NRC Staff Request for Additional Information on the Draft Basis for Section 3116 Determination and Associated Performance Assessment for the H-Area Tank Farm at the Savannah River Site

Executive Summary

Figure 1. Illustration of the as-modeled annular waste and fast pathway in Tanks 9H and 10H

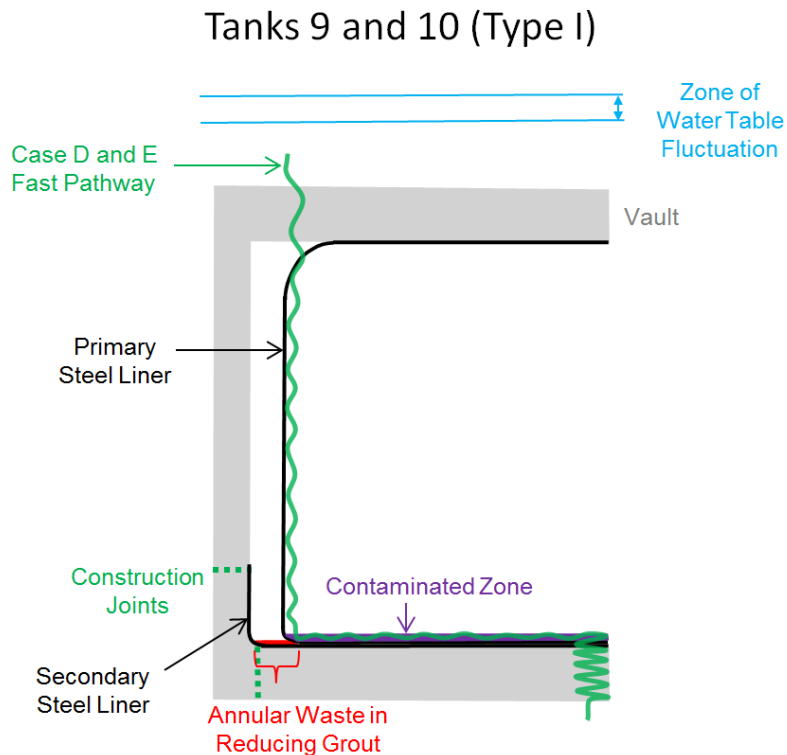
In DOE's PORFLOW[®] model (see Figure 1), the annular waste in Tanks 9H and 10H is loaded within the bottom of the annular reducing grout. Loading of the annular waste into the bottom of the reducing grout in DOE's PORFLOW[®] model assigns K_d values associated with reducing grout. For redox-sensitive radionuclides, this appears to significantly limit mobility even though this waste is assumed to be highly mobile. In addition, the preferential pathway represented in cases B-E does not intersect the annular waste in Tanks 9H and 10H. Based on operational experience, NRC staff is concerned that groundwater in-leakage into the annular region could occur and that the associated risk with this scenario is not adequately addressed within the Performance Assessment.

Figure 2. Illustration of the as-modeled sand pad waste and fast pathway in Tanks 14H and 16H

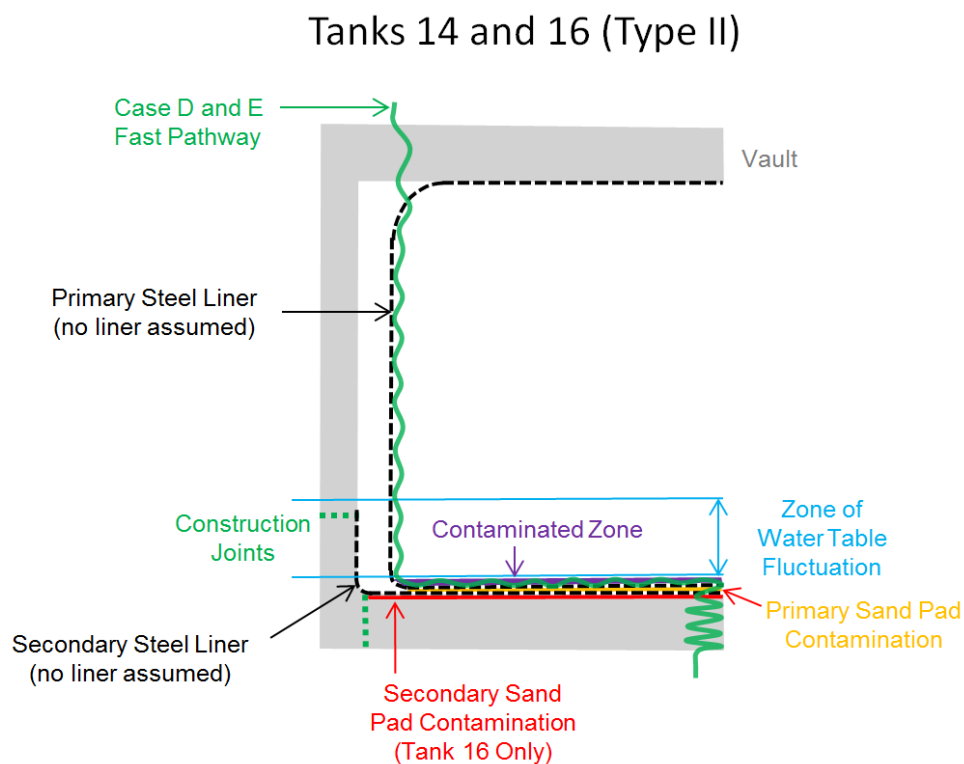
addition, the HTF Performance Assessment does not discuss the extent of diffusion out of the sand pads and into the adjacent cementitious materials.

It appears that a potentially significant fraction of the highly radioactive radionuclide inventory is diffusing into the basemat and/or contaminated zone prior to release. Diffusion of radionuclides out of the primary and secondary sand pads is facilitated in the model by a high diffusion coefficient, large concentration gradient, small diffusion length, assumption of no steel liners, and a delay in the flow through the fast pathway due to closure cap. Although the steel liners are not assumed to not be intact for Tanks 14H and 16H due to the large number of leak sites, the steel liner could still act as a partial barrier to diffusion. Also, the delay in flow through the preferential pathway, due to the assumption of flow being limited to infiltration through the closure cap, may overestimate the amount of time radionuclides can diffuse out of the sand pads if groundwater in-leakage were to occur.

short-lived radionuclides (e.g., cesium-137 and strontium-90) that decay prior to significant flow occurring in the fast flow path. DOE should also provide discussion regarding the fraction of the highly radioactive radionuclides (e.g., technetium, plutonium, and neptunium) that diffuse out of the sand pads and into the grout or basemat.
